**SUBJECT:** (6.1) 60 Kareela Road, Cremorne Point - Construction Traffic Management Plan - (Demolition Stage only)

**AUTHOR:** Report of Traffic & Transport Engineer, Iman Mohammadi

Council has received a “Traffic Impact Assessment” prepared by “PTC Consultants”, dated 7 January 2020 for the approved development at 60 Kareela Road, Cremorne Point (Development Consent 202/19).

Figure 24 – Proposed Temporary Parking Controls

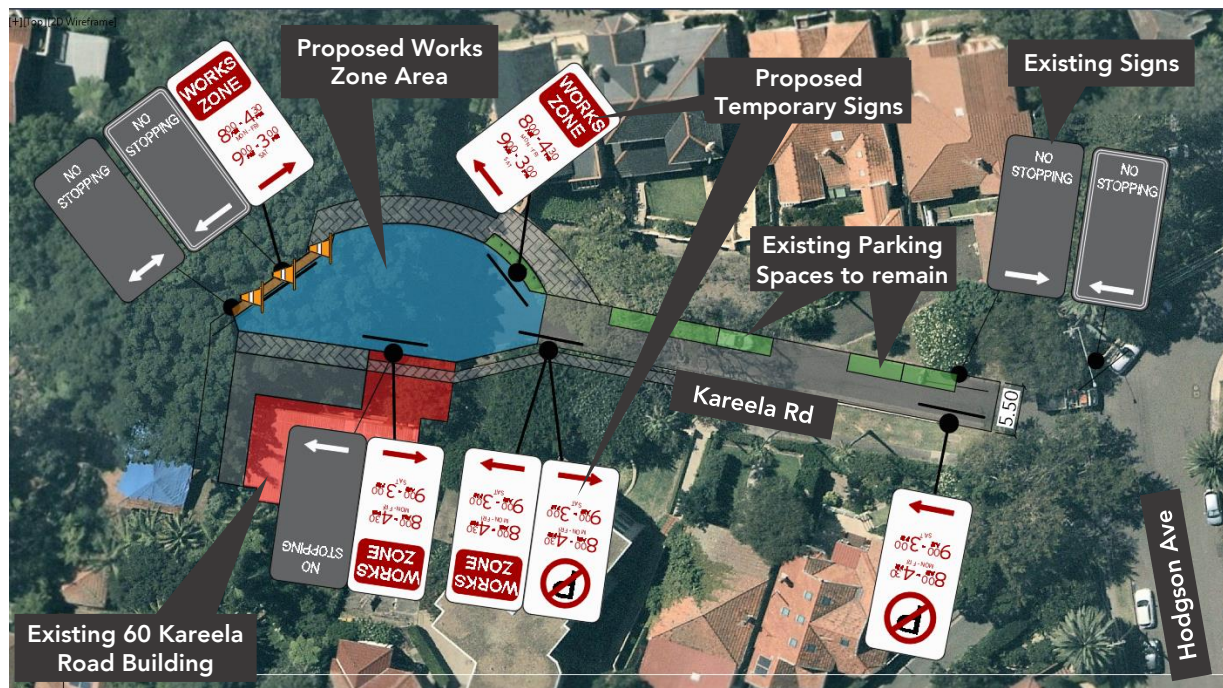
The “Work Zone 8am-4:30pm Mon-Fri and 9am-3pm Sat” signs on the eastern side of cul-de-sac (opposite the site) as shown on figure 24 “Proposed Temporary Parking Controls” on page 29 of the report shall be changed to “No Stopping 8am-4:30pm Mon-Fri and 9am-3pm Sat”

11. The "Work Zone 8am-4:30pm Mon-Fri and 9am-3pm Sat" signs on the eastern side of cul-de-sac (opposite the site) as shown on figure 24 "Proposed Temporary Parking Controls" on page 29 of the report shall be changed to "No Stopping 8am-4:30pm Mon-Fri and 9am-3pm Sat"
